# FORMAL OBJECTION REGARDING STATE SIGNIFICANT DEVELOPMENT (SSD-96272465) – 11-23 RANGERS AVENUE, MOSMAN

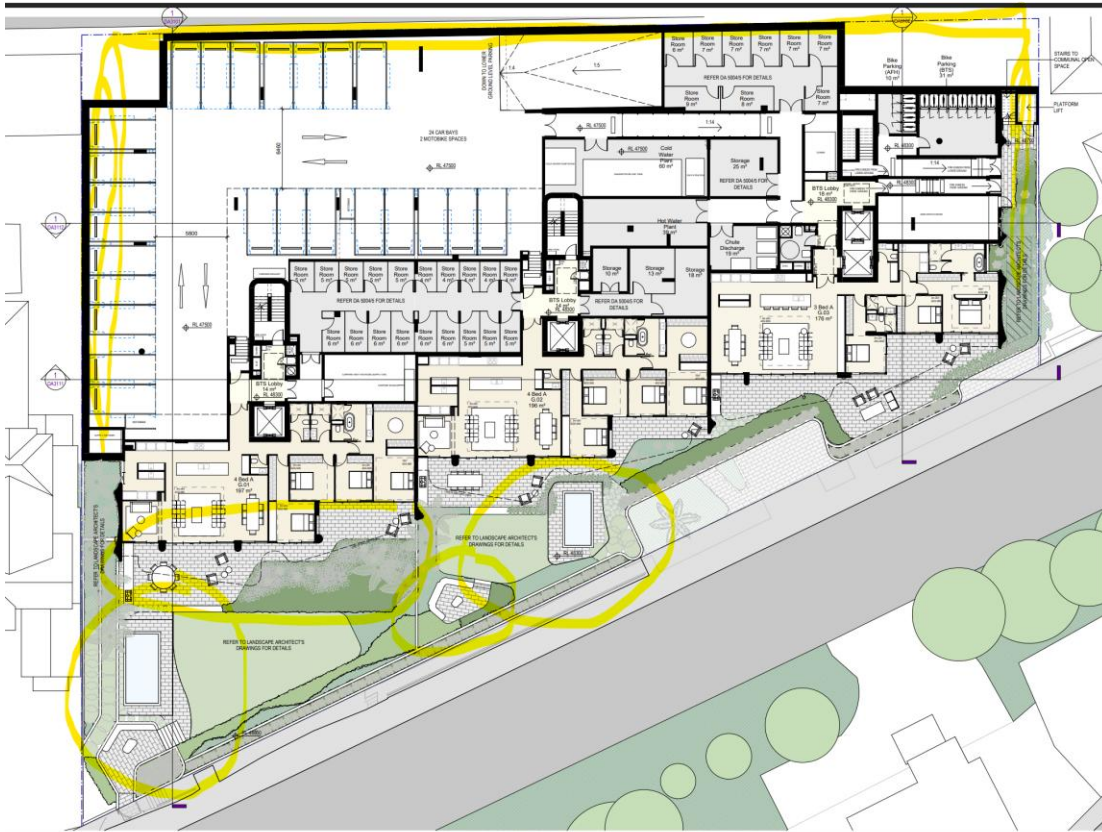
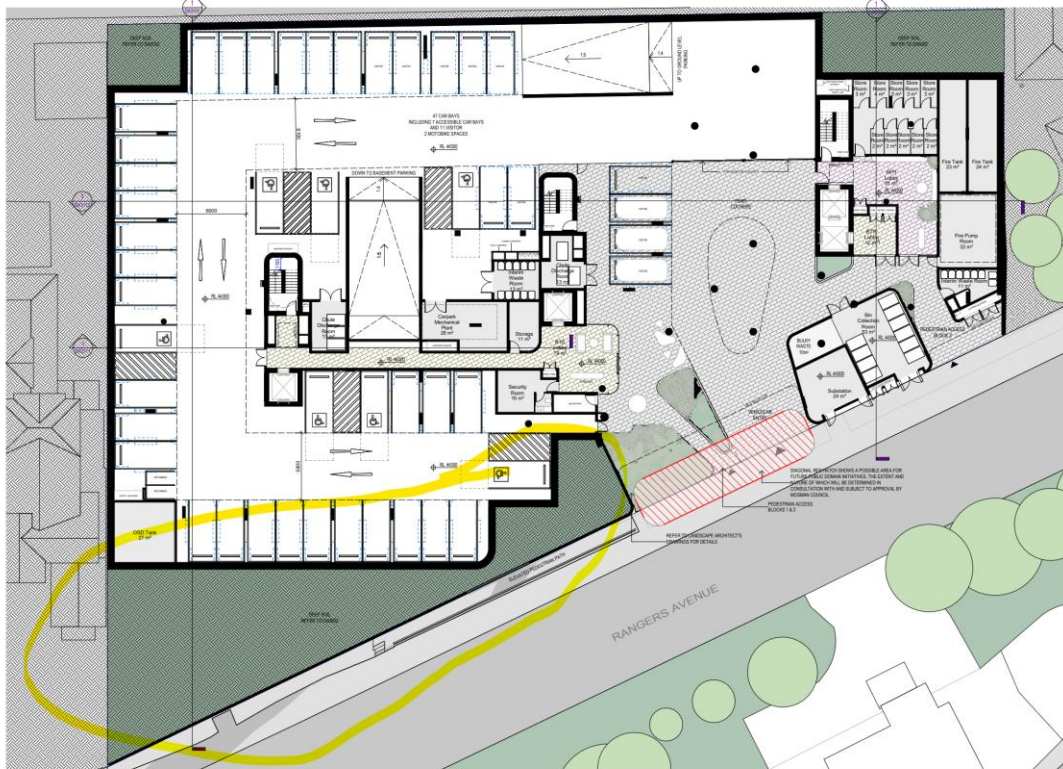
**The above drawings clearly show a failure to;**

- i. Contain parking levels within the building footprint;
- ii. Adhere to the definition of Deep soil zones per 3E of the ADG: Deep soil zones are areas of soil not covered by buildings or structures within a development. They exclude **basement car parks**, services, **swimming pools**, tennis courts and **impervious surfaces** including car parks, driveways and roof areas.

- i. **Encroachment by Car Parking (Eastern, Northern, and Western Boundaries):**
  - o The DA Drawing Set (DA2008, DA2009, DA2010) confirms that the basement car parking structure extends right up to the boundaries on the Eastern, Northern, and Western sides of the property.

- o **The Defect:** A "Deep Soil Zone" is legally defined as an area of soil "**not covered by buildings or structures within a development... above and below ground**". The basement and car parking directly beneath the boundary strips mean this land is **not deep soil** and cannot support the large trees proposed for privacy mitigation.

- iii. **Pools and hardstand in Deep Soil Zone – failure of ADG;**
  - o The Proponent has two swimming pools and hardstand (as highlighted in the above pictures from their plans) in the Deep Soil Zone.

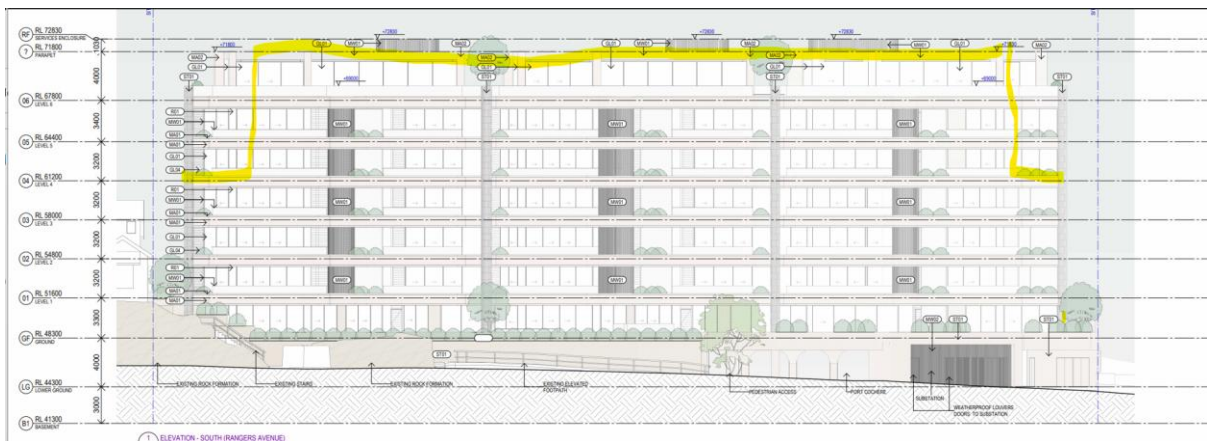
- c) Failure of Proportional Setback (ADG 2F & 2G): The General Elevations - South (DA3002) confirms the massing presents as a continuous, sheer wall running vertically from the Ground Floor up to Level 6 (Level 7 in the floor system). This design violates ADG Objective 2F (Building Separation) and Objective 2G (Street Setbacks) which require building separation to be increased proportionally to the building height and the upper levels to be recessed to achieve better amenity and privacy.
- d) Unmitigated Visual Bulk: The failure to introduce a substantial step-back at the mid-levels (such as Level 4) maximizes the visible bulk, creating an

unacceptable, monolithic structure that is contrary to the urban design principles of articulation and scale management in a sensitive transition zone.

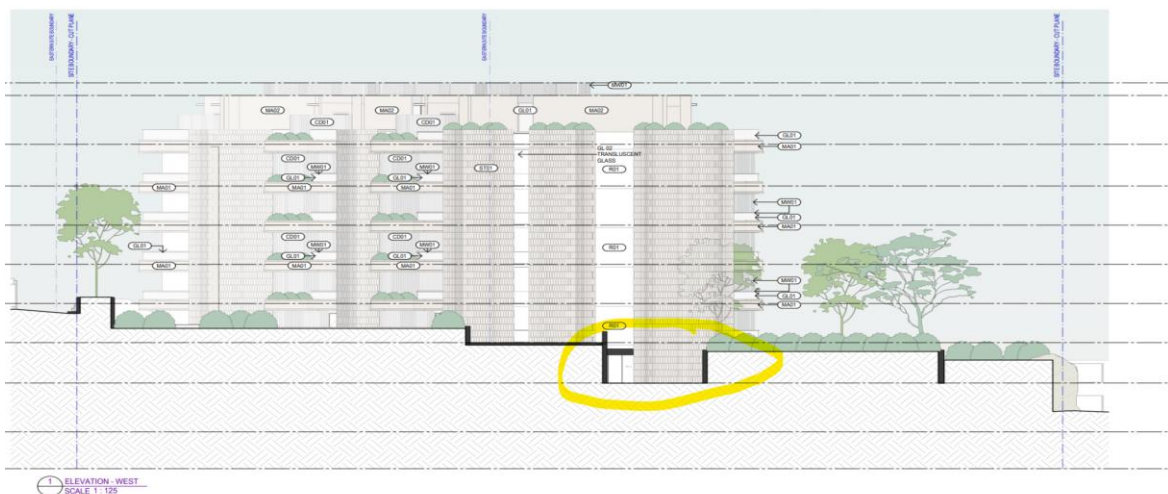
The insertion of an undocumented, structural opening—likely a utility access hatch, maintenance point, or basement ventilation light well—at the base of the western façade fundamentally invalidates the **Proponent's** entire strategy for managing the sensitive interface with 25 Rangers Avenue.

- ii. **The Breach:** The existence of a permanent **access point/hatch** at the boundary line directly next to sensitive areas (children's bedrooms, glass-roofed children's bathroom, and pool area) creates an unacceptable visual intrusion risk. This requires regular maintenance access, meaning workers will gain an unmitigated, direct line-of-sight into the highly private and vulnerable spaces of our home. This is a severe breach of **ADG Objective 3F (Visual Privacy)**.

- i. If this opening is designed as a **basement ventilation system** (common on the lowest exposed levels of deep basement structures), it introduces a continuous acoustic threat.
- ii. **ADG Objective 4H (Acoustic Privacy)** guidance mandates that noise sources such as "**garage doors, driveways, service areas, plant rooms... should be located at least 3m away from bedrooms**". Since the proponent's setback is only 3.0 metres to the nearest building line, locating a service opening *on* the boundary line subjects our **Habitable Rooms** (children's bedrooms) to unacceptable and continuous mechanical noise.

- i. The **Proponent's** promise of a green buffer is predicated on the 3.0-metre setback functioning as a Deep Soil Zone for planting.
- ii. The structural requirement of this access point—which extends to the Basement/Lower Ground structure (RL 44300)—means that this area is now a permanent hardstand or structural element, directly contradicting the need for soil and the long-term viability of any large, mature tree planting. This reinforces the finding that the design **fails to meet the ADG's 6.0-metre minimum dimension for Deep Soil Zones**, rendering the entire vegetative screening claim null and void.

**Demand:** No structural openings, service access points, or ventilation apertures are permissible on the western boundary where they compromise the ADG's visual privacy and acoustic amenity standards for adjoining **Habitable Rooms**.
